HISTORIC LANDMARK COMMISSION
APPLICATION FOR A CERTIFICATE OF APPROPRIATENESS
JULY 27, 2020
C14H-2011-0002
ROUTON-ALVAREZ-LOPEZ HOUSE
809 E. 9TH STREET

Construct a mid-rise residential tower adjacent to the house.

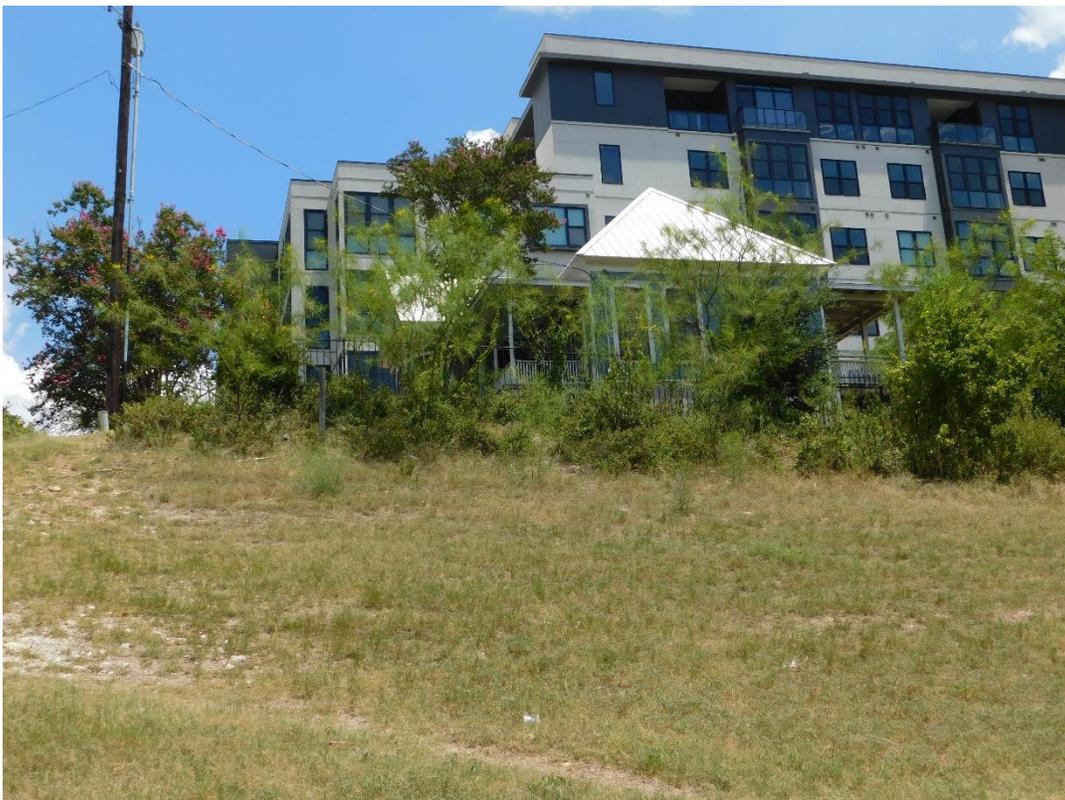
The Committee expressed concerns about the scale of the proposed new building and suggested pulling back the ground floor or providing some sort of transition zone to increase the distance between the old and the new. The Committee also suggested removing the horizontal siding from the first two floors of the new building as it competed with the horizontal siding of the historic house.

Approve as proposed with the recommendation to consider the Committee's recommendation regarding the siding. The proposed new building is very close to the historic house, and increasing the sense of separation between the two will be beneficial to retaining more of the integrity and historic context of the house. Vegetation or a planting of small trees between the two might present a greater visual separation between the buildings.
